STATE OF MAINE
DEPARTMENT OF TRANSPORTATION
16 STATE HOUSE STATION
AUGUSTA, MAINE 04333-0016

January 22, 2018
Subject: Billings Bridge
Superstructure Replacement
State WIN: 022618.00
Location: **Paris**
Amendment No. 2

MILL AND INLAY DETAIL

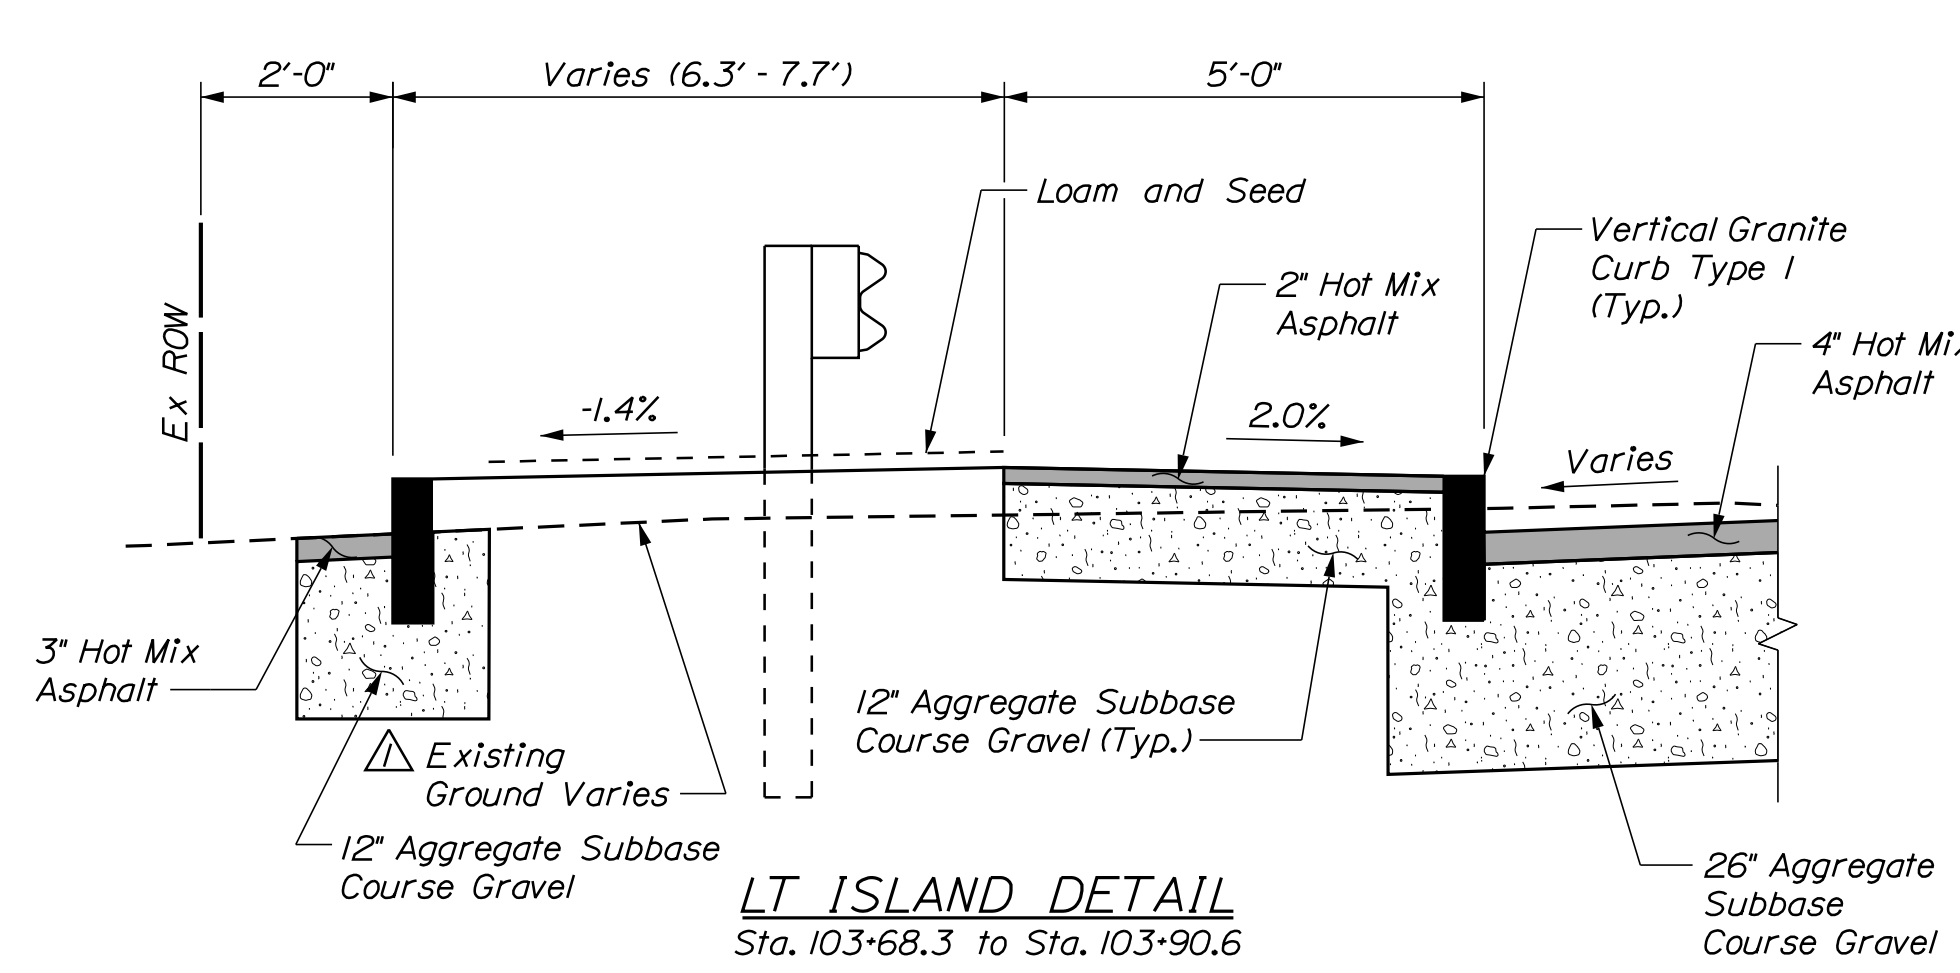
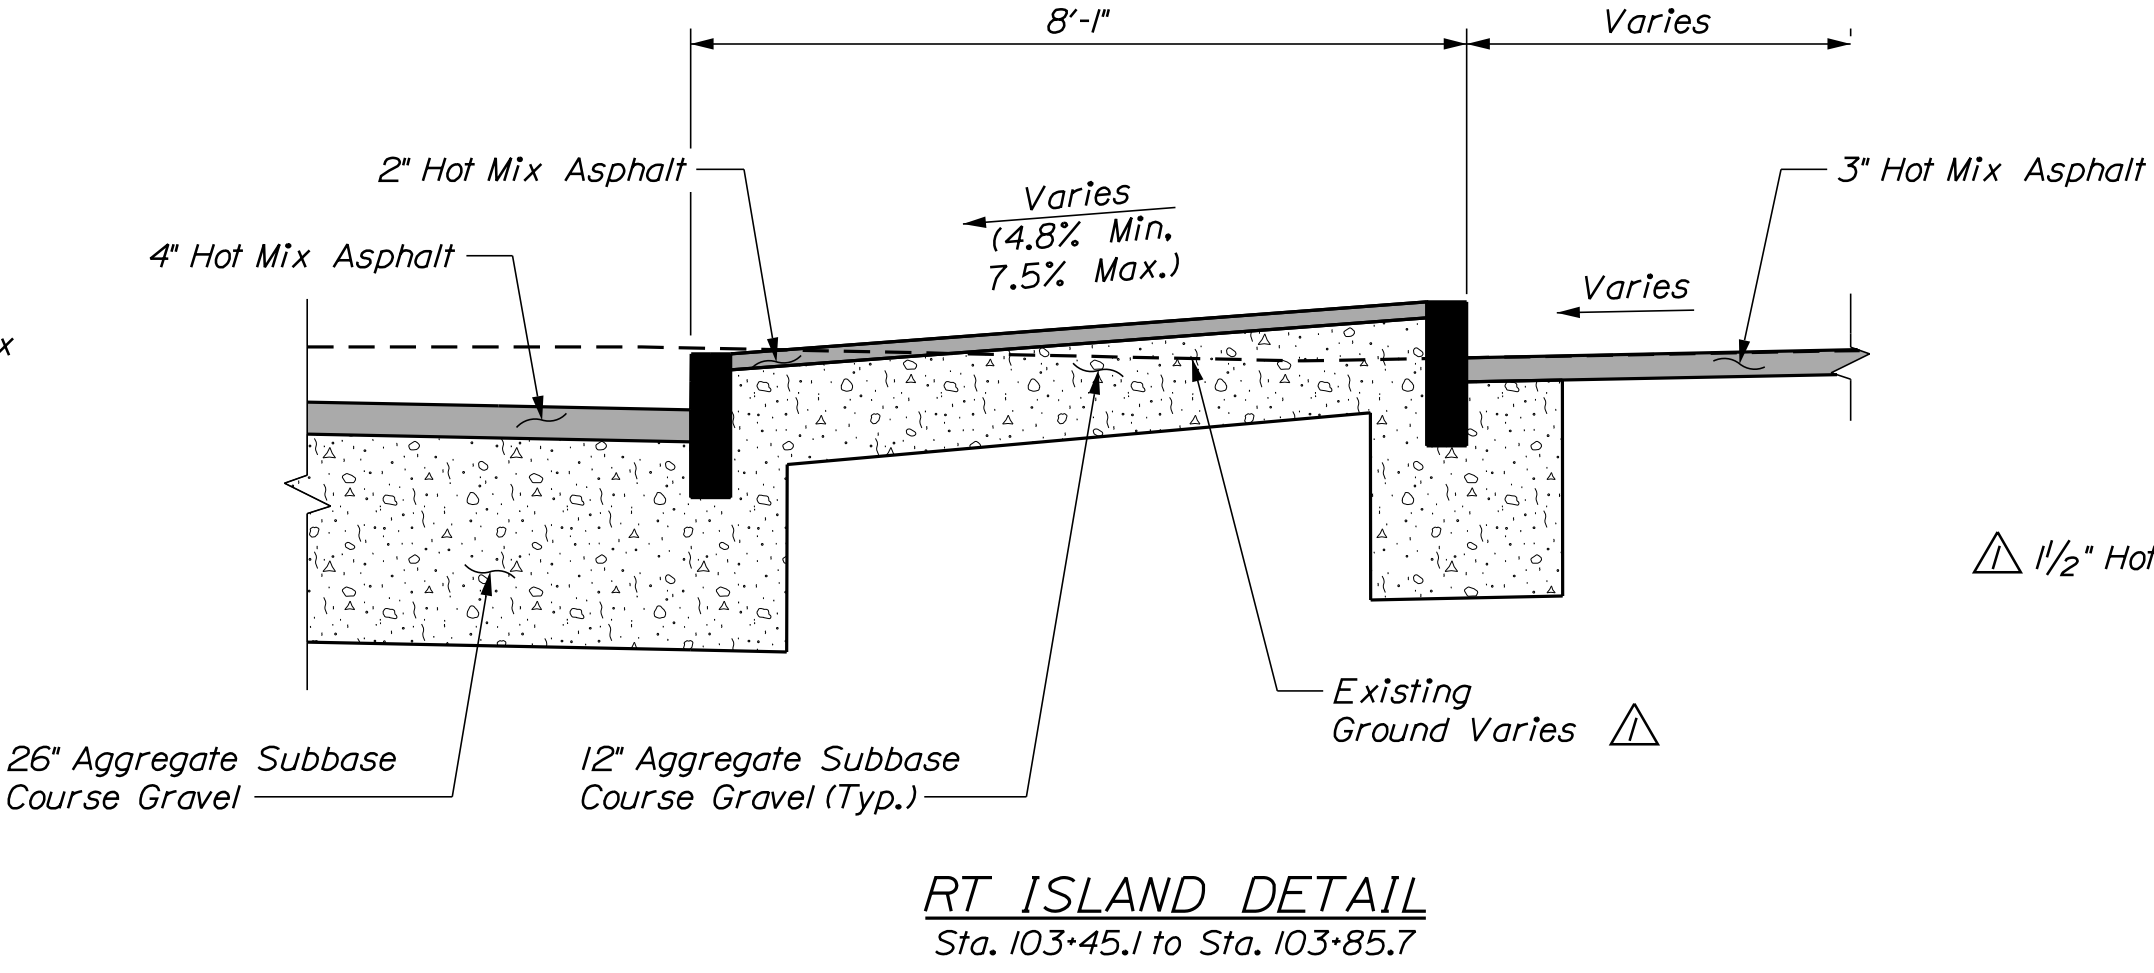
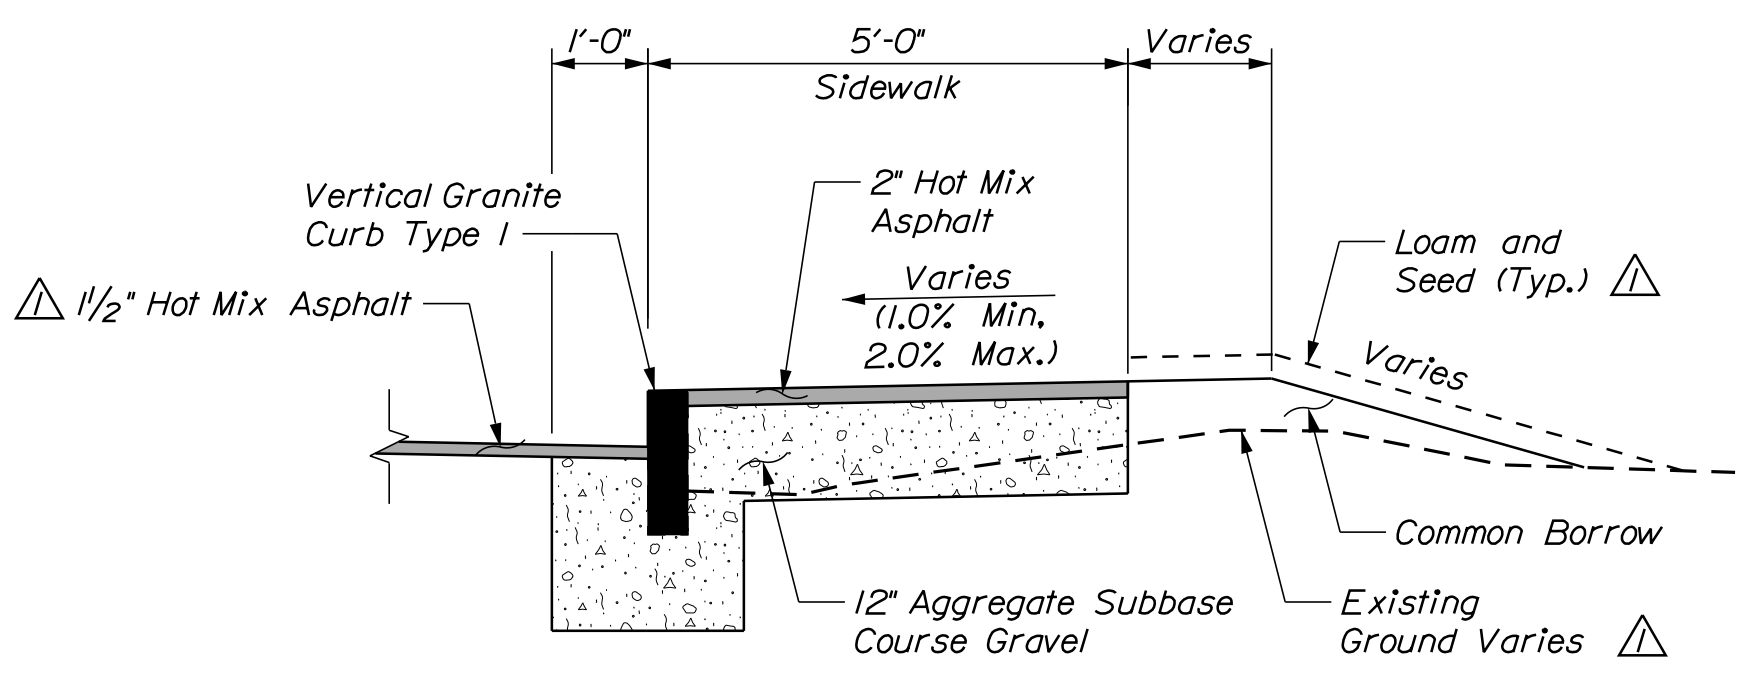
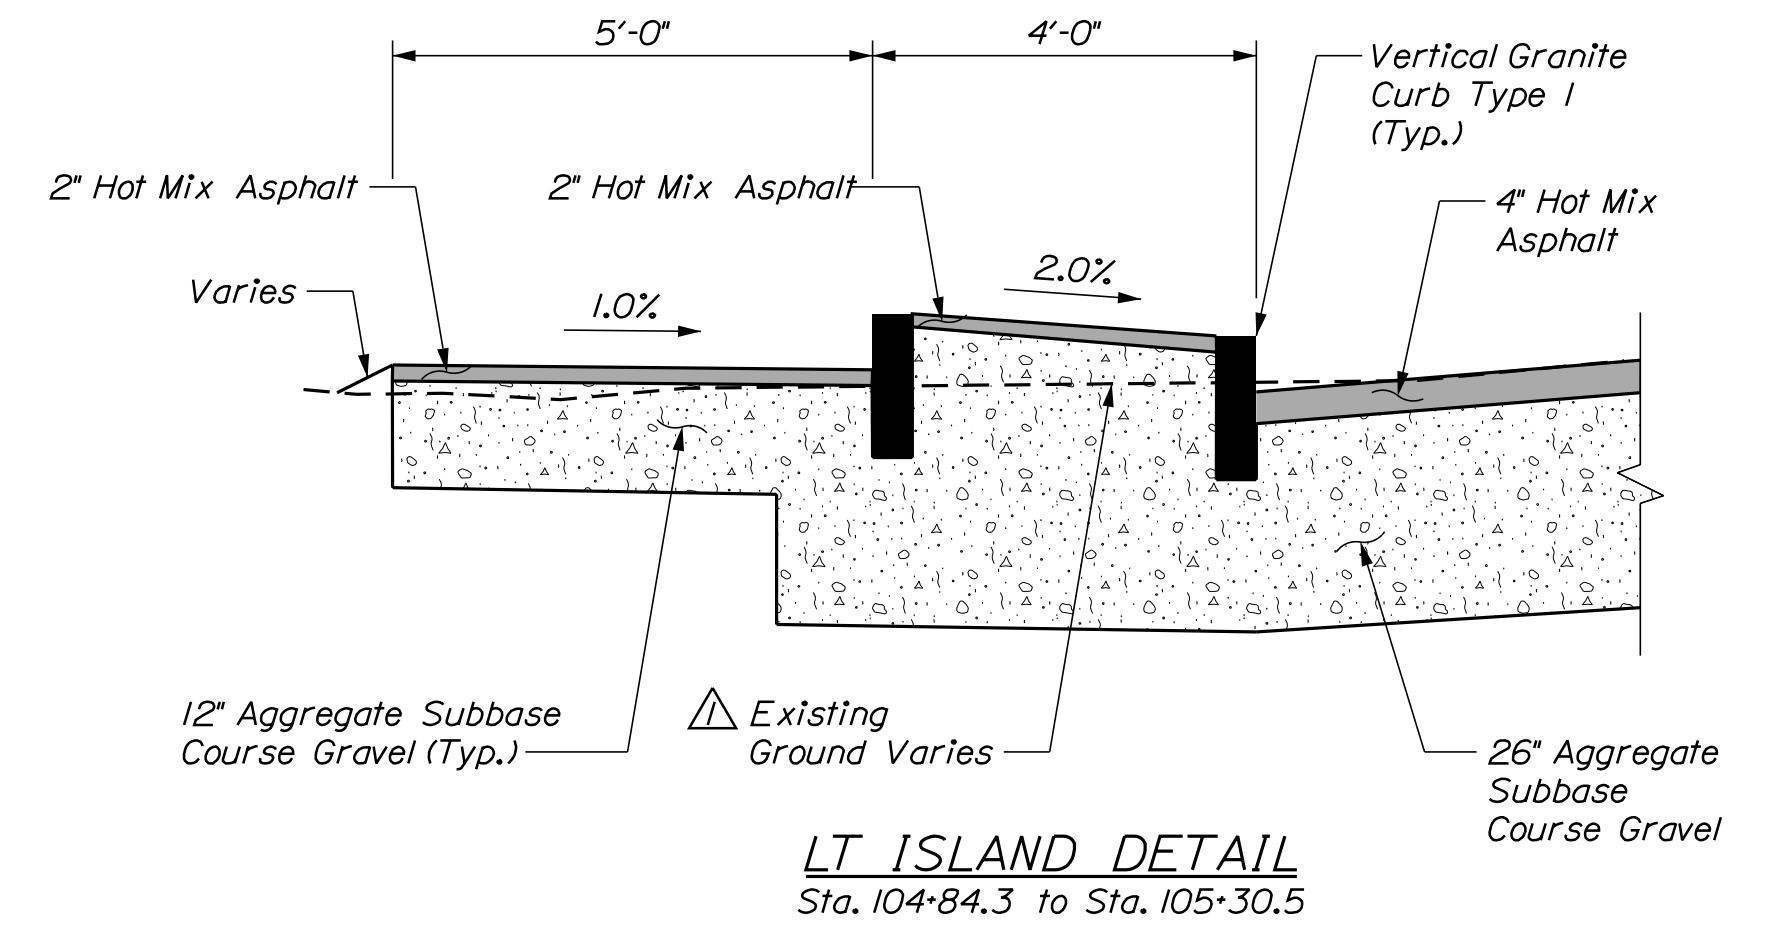
Question: Sheet 5 of 57 indicates mill and overlay from STA 99+60 to 100+35 and 105+50 to 105+75, but there is no bid item 202.202. Is there milling on the project, and if so could an item be added?

Response: Please see the attached, revised Proposal Schedule of Items.
